#### **Addendum 9 – UN Regulation No. 10**

#### **Revision 6 - Amendment 2**

Supplement 2 to the 06 series of amendments – Date of entry into force: 8 October 2022

#### **Uniform provisions concerning the approval of vehicles with regard to electromagnetic compatibility**

"Figure 1

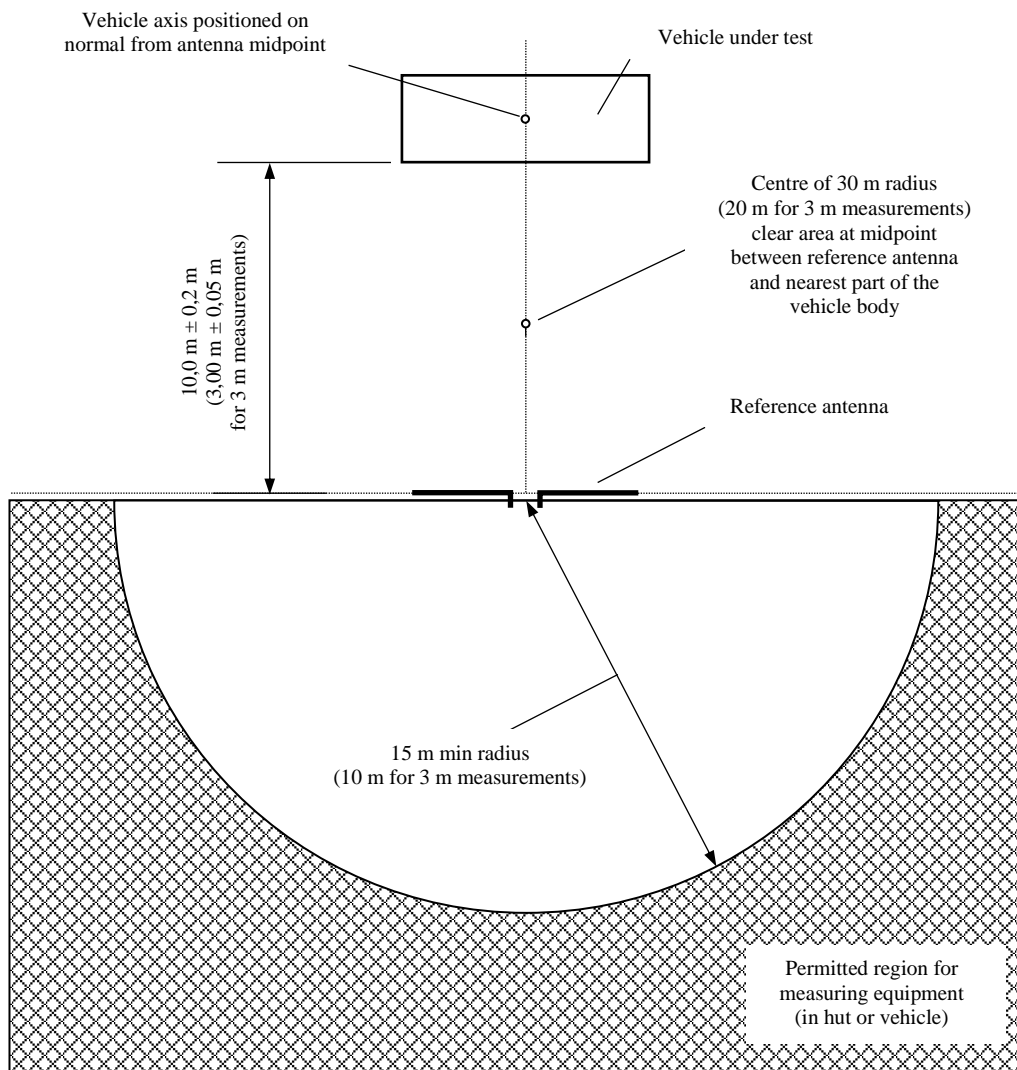
Annex 4 - Appendix 1,

Figure 1, amend to read:

Clear horizontal surface free of electromagnetic reflection delimitation  
of the surface defined by an ellipse
